ARCHITECTURAL & DESIGN REVIEW APPLICATION

Project Address: 2674 Botanical Drive **Lot:** 7 **Subdivision:** Hartung Fields

RESPONSE LETTER

To: City of Fitchburg - Planning/Zoning Department
Attn. Deanna Schmidt, City Planner & Zoning Administrator
5520 Lacy Road
Fitchburg, Wisconsin 53711
via email delivery only

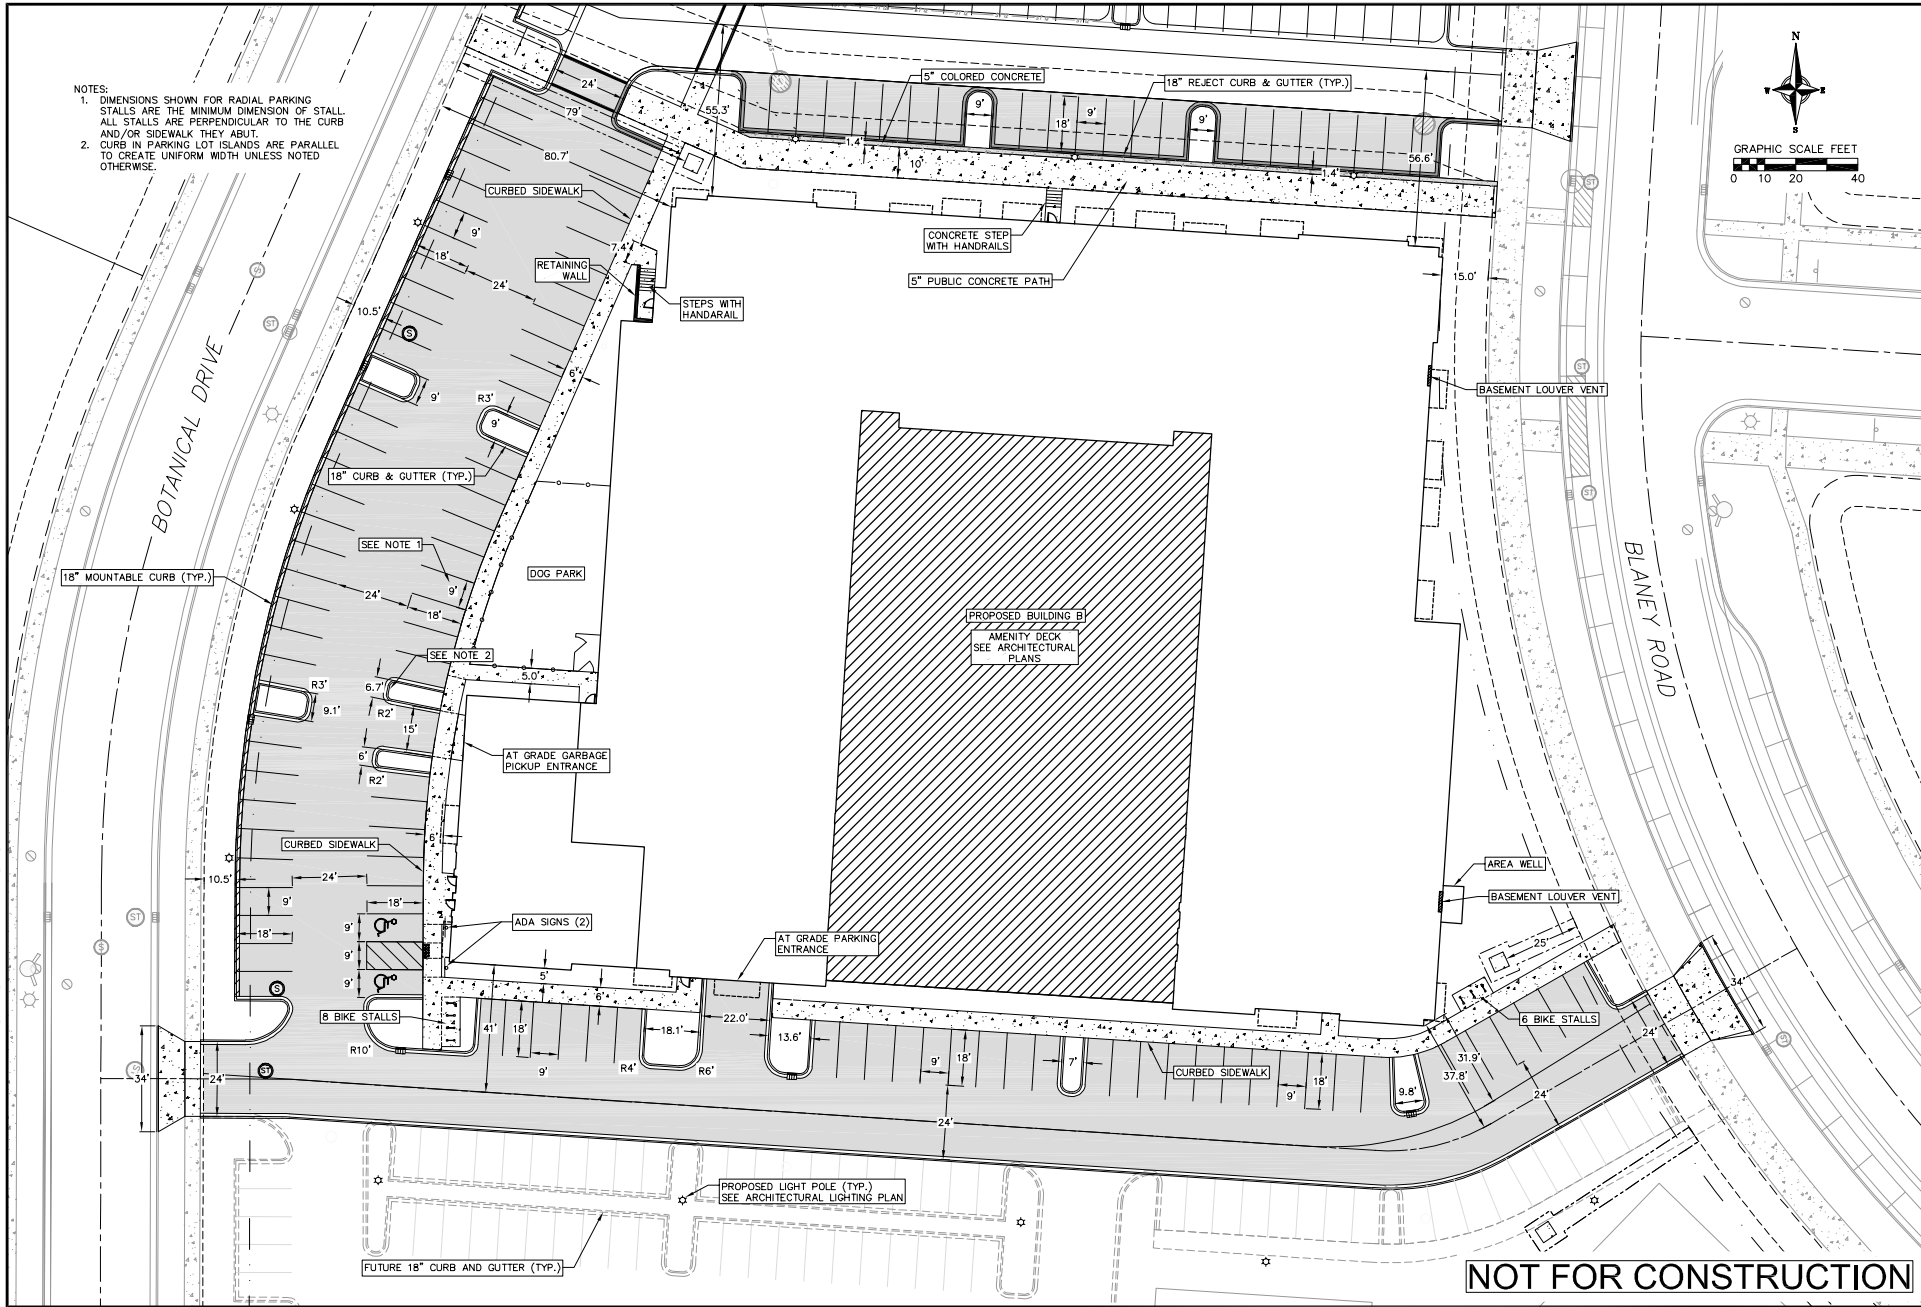
- Please see the public path detail on Sheet C602, and general notes 7 & 8 on C001.
 - Noted ref the r/w permit and timing requirements
3. Label the concrete between the 10' public concrete path and th curb as 5" thick colored concrete. Minimum required width of the colored concrete is 1.4 feet.

- Please see C200 Site Plan.
4. Provide a detail for the public 10' wide concrete path in the plans and for City review. 10' path needs to be 5" concrete on 8 inches of 3/4" aggregate base. Joints shall be sawcut at min. 10' intervals.

1 5" PUBLIC PATH
602 NOT TO SCALE

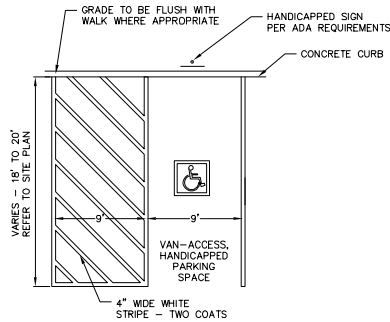
- We will comply with lighting requirements as outlined in Ch.28, and as per our previous projects.
2. Provide a detail for the 10' wide concrete path in the plans and to the City for review. Path shall be 5" thick with 8 inches of 3/4" aggregate beneath it. All joints shall be sawcut and maximum 10' even intervals. Note on the plans that this path shall be constructed in accordance with the City of Fitchburg Standard Specifications for public Works Construction, latest edition. A City of Fitchburg r/w permit is required before any work may begin on this path. This path shall be installed and accepted by the City prior to occupancy.

- Please see the public path detail on Sheet C602
5. Add a note on the plans that the 10' concrete path shall be installed per the latest edition of the City of Fitchburg Standard Specification for Public Works Construction. A City of Fitchburg r/w permit is required for for this path.

LINE OF SIGHT SECTION 01
 3/32" = 1'-0"

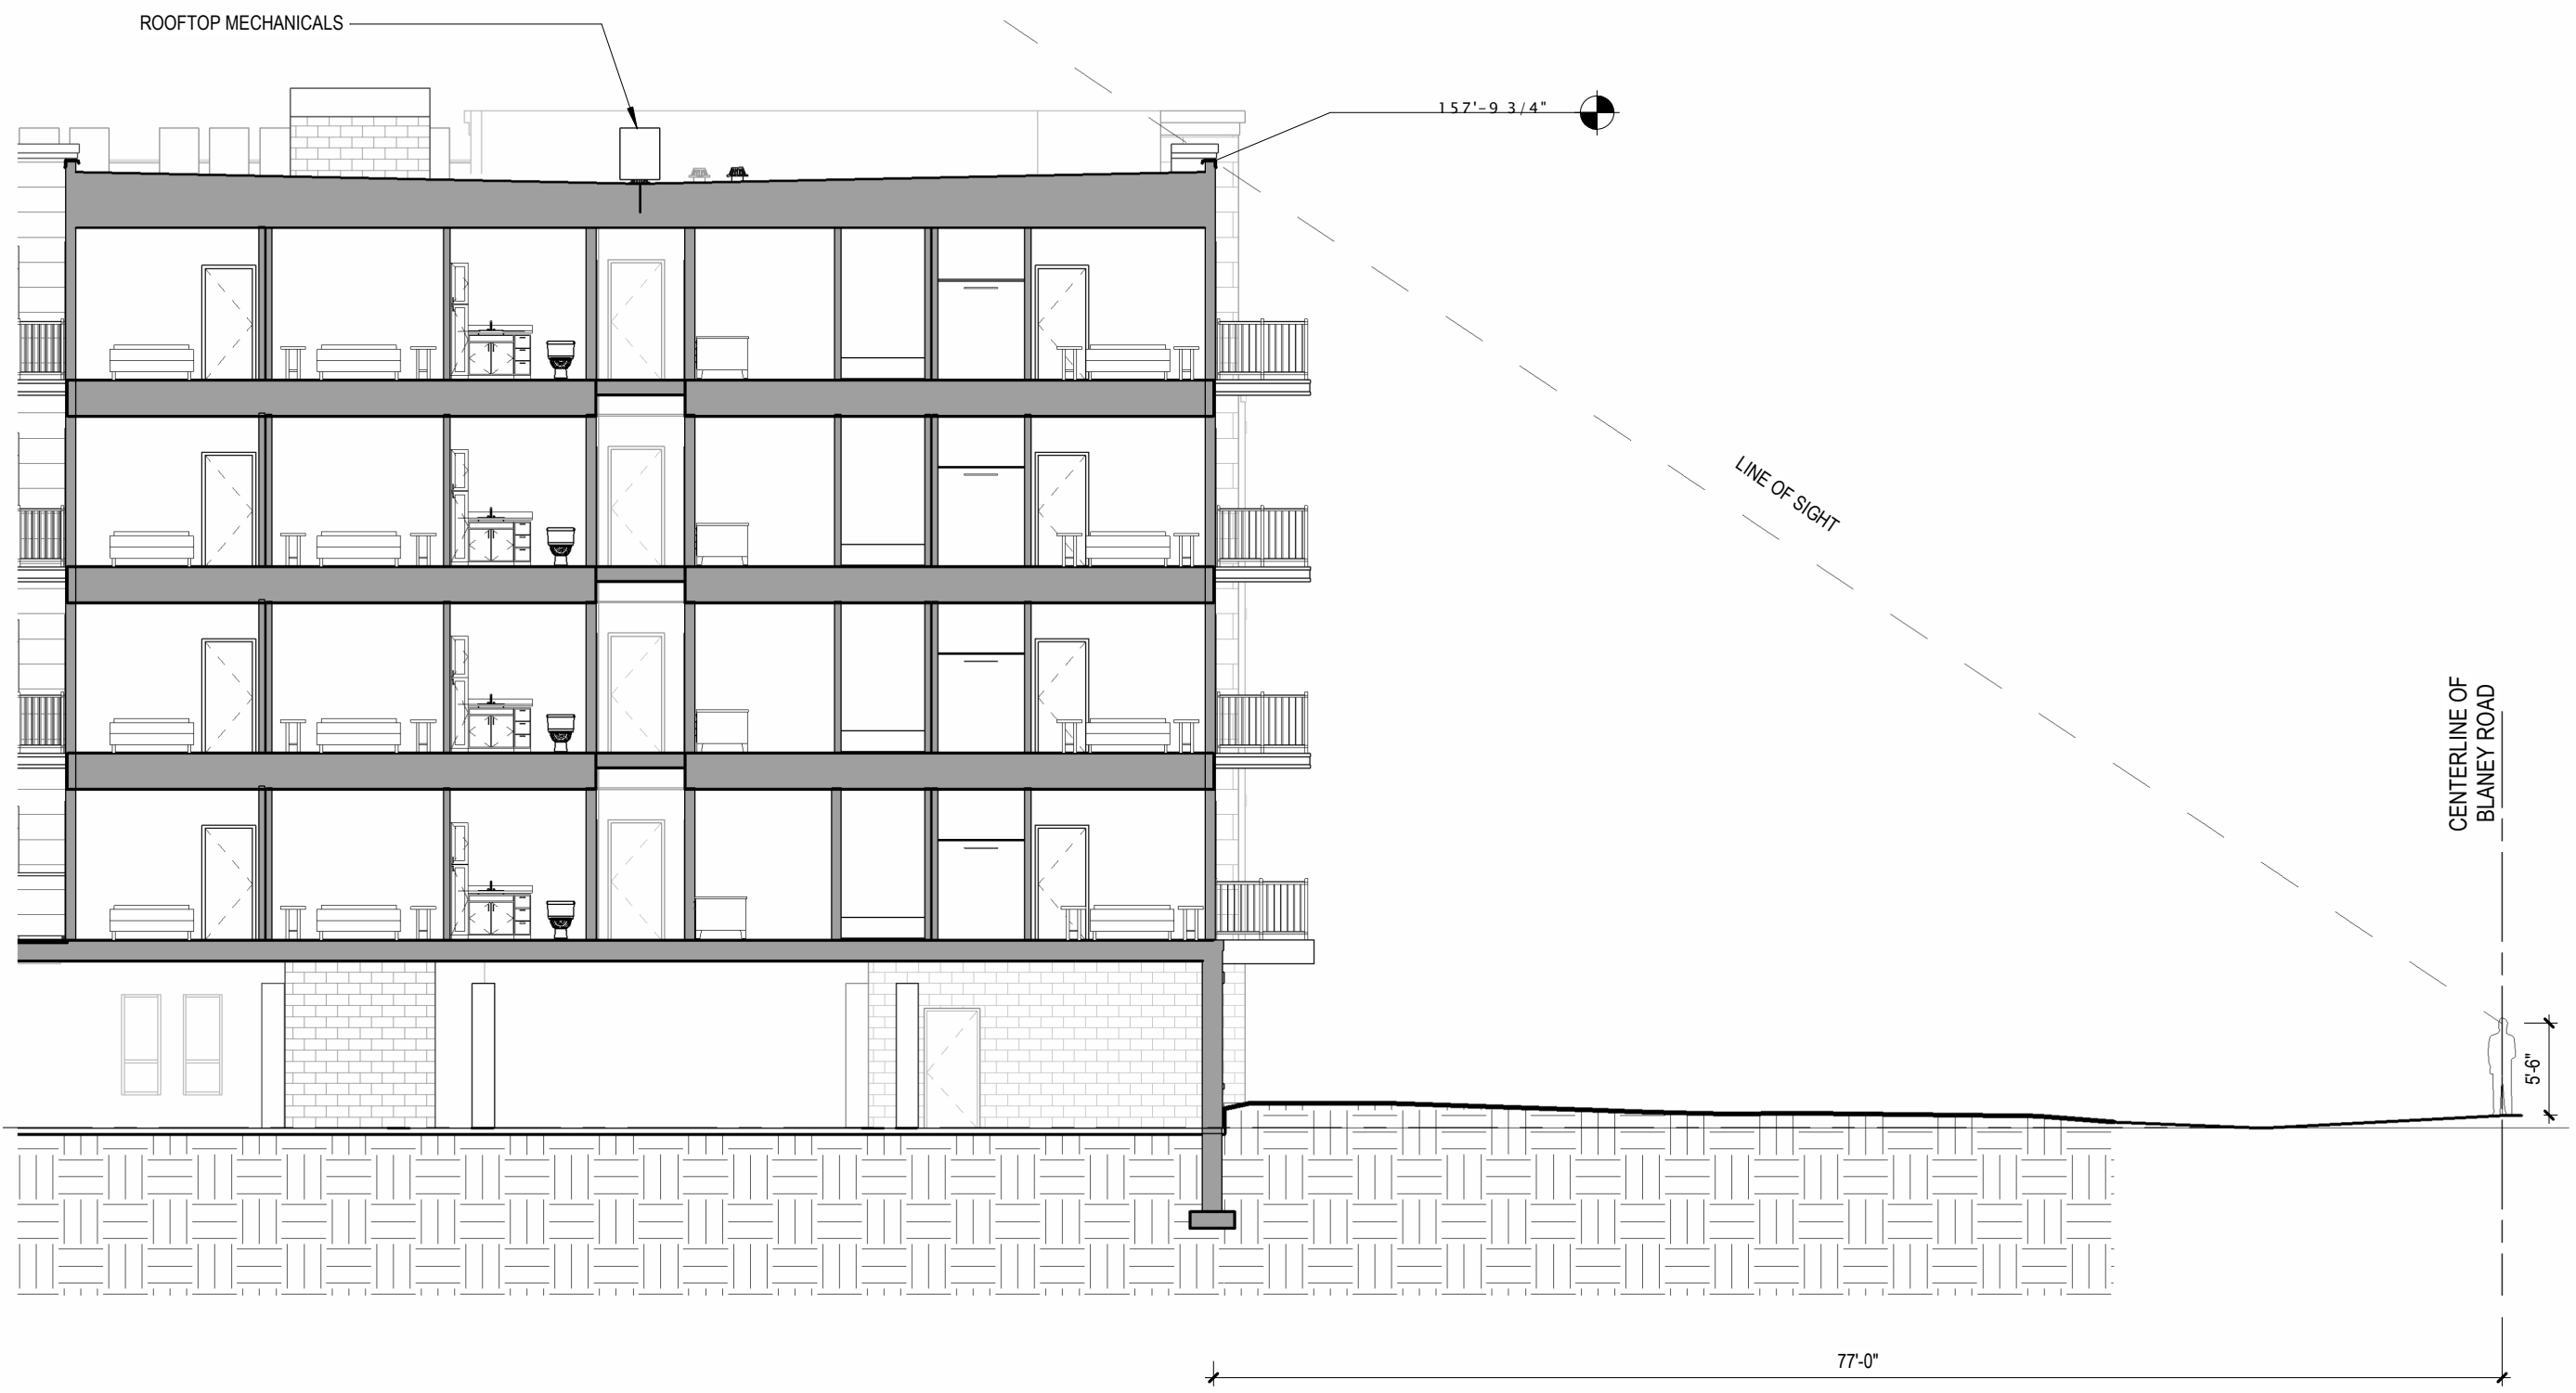
8. Please detail any rooftop electrical/mechanical equipment to be screened?
 - The parapet walls and the addition of solar panels will help screen the mechanical units. Per the roof plans, the mechanical units are located on the center of the building roof line. From a pedestrian or vehicular perspective, the roof equipment would be difficult to see due to the viewing angle from at grade. Please see attached "Line of Site" exhibit to further clarify.
